Crane Division, Naval Surface Warfare Center (NAVSURFWARCENDIV) submits, as enclosure (1), three copies of the Draft Phase II Soils Report for Solid Waste Management Unit 10/15, Rockeye. The required Certification Statement is included as enclosure (2).

RFI PHASE II SOILS
REPORT FOR:
ROCKEYE, SWMU #10/15
NAVAL SURFACE WARFARE CENTER, CRANE, INDIANA

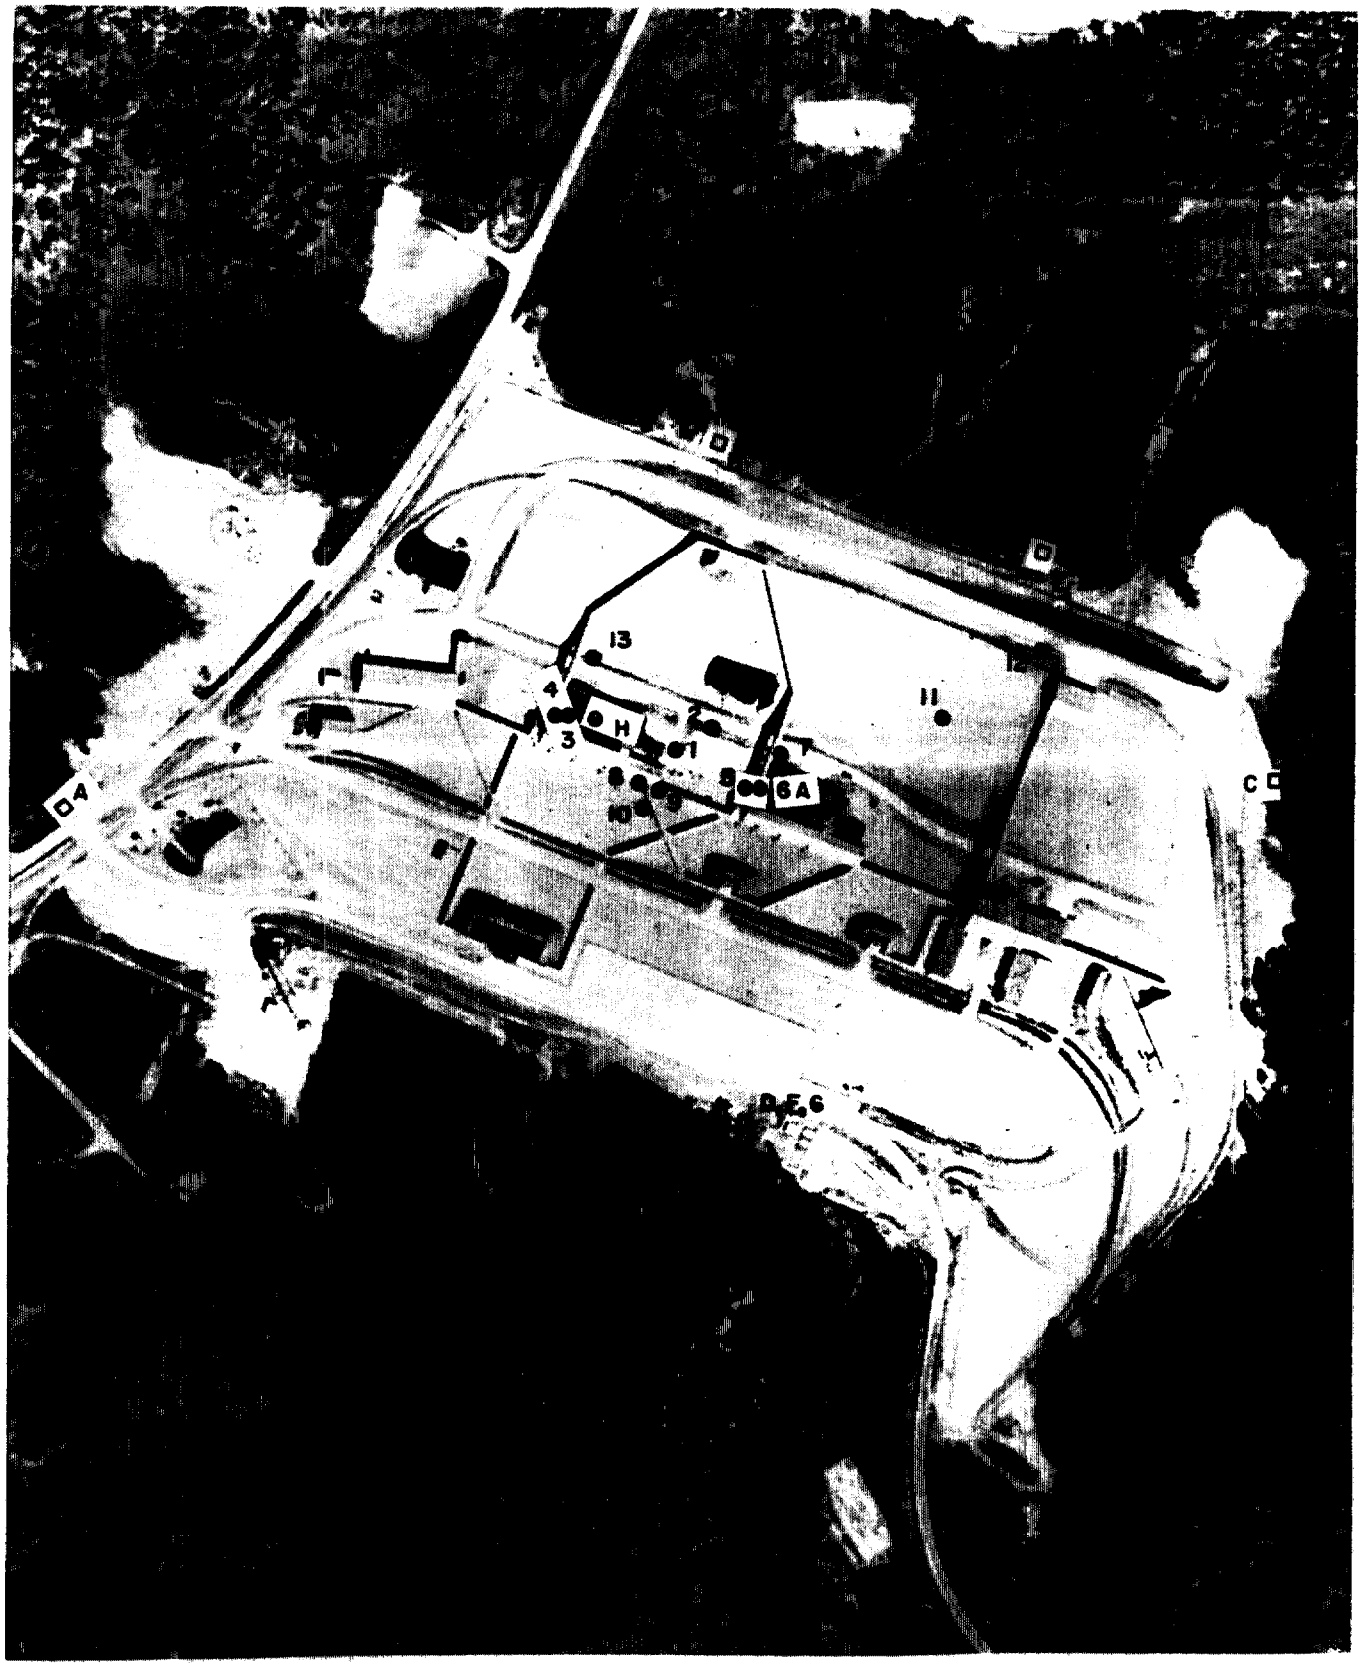
13. Figure 5.1
